## Blocking of unintentional starter motor engagement

### Background

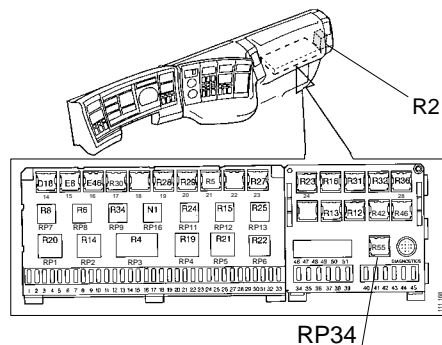
The problem is solved by fitting a protective circuit in the central electric unit. The circuit prevents the starter motor from being engaged while the engine is running.

3. Insert cable harness 1 422 862 according to wiring diagram.
4. If required, detach R2 from mounting plate or remove the nearest control unit. If vehicle is fitted with VPS (Vehicle Protection System), remove VPS battery. Refer to illustration above for component location.

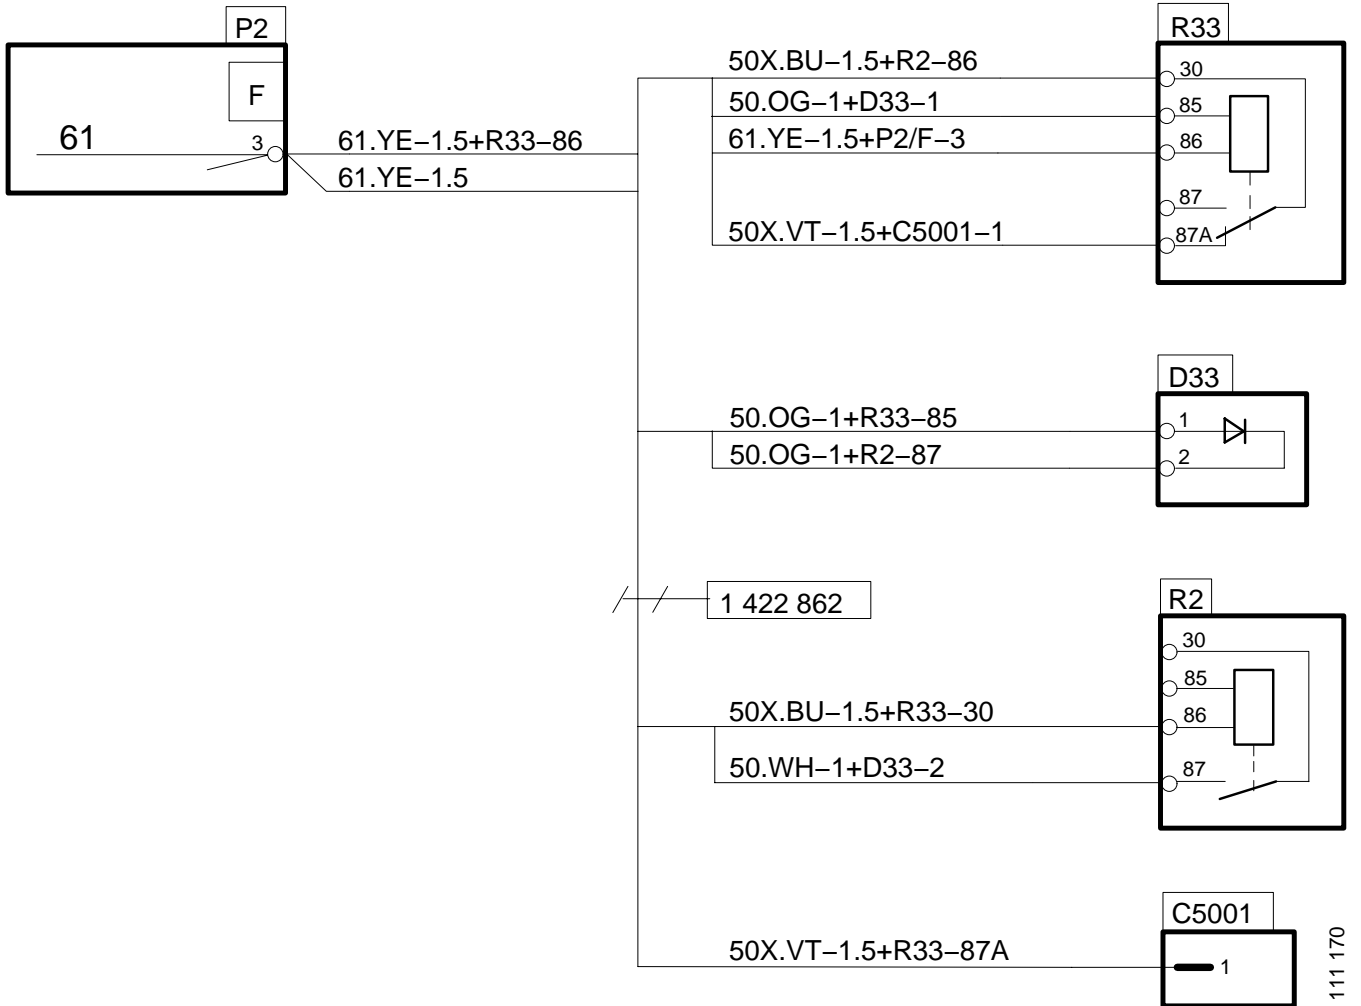
5. Detach cable 50X.VT-1,5 from relay R2-86. R2 is fitted to underside of mounting plate, below central electric unit. Remove existing cable terminal from cable by cutting. Strip cable as required and crimp on cable terminal 815 699. Insert cable terminal into new connector marked C 5001.

6. Detach cable from R2-87 (50.Wh-4). Fit cable with ring terminal 50.WH-1 in cable harness 1 422 862 to R2-87. Position new ring terminal lowermost and refit detached cables on top.

7. Connect cable harness cable marked 50X.BU-1,5 to relay R2-86.
8. Connect new part of connector C 5001 with existing part in cable harness.
9. Attach new cable harness to existing cable harness. Tie up cables towards central electric unit, where any excess cable can be placed.
10. Remove cable terminal P2/F-3 from central electric unit using tool 588 198.

13. Refit cable terminal in position P2/F-3.  
Engage connector lock.
14. Insert connector for R33 in relay position  
RP34. Insert relay in relay holder.

**Note!** Relay R33 for starter blocking must always be fitted in relay position RP34. If RP34 is occupied by other relay, move this to other suitable position.

15. Attach diode D33 to existing cable harness by means of cable tie.
16. Reconnect vehicle power supply.
17. Check function as follows:
  - Start engine: Result: Normal starting possible.
  - Switch off engine and remove relay R33.
  - Try to start engine. Result: Starting not possible.
18. Close central electric unit and refit any detached control units and (if fitted) the VPS battery. Refit covers below central electric unit.
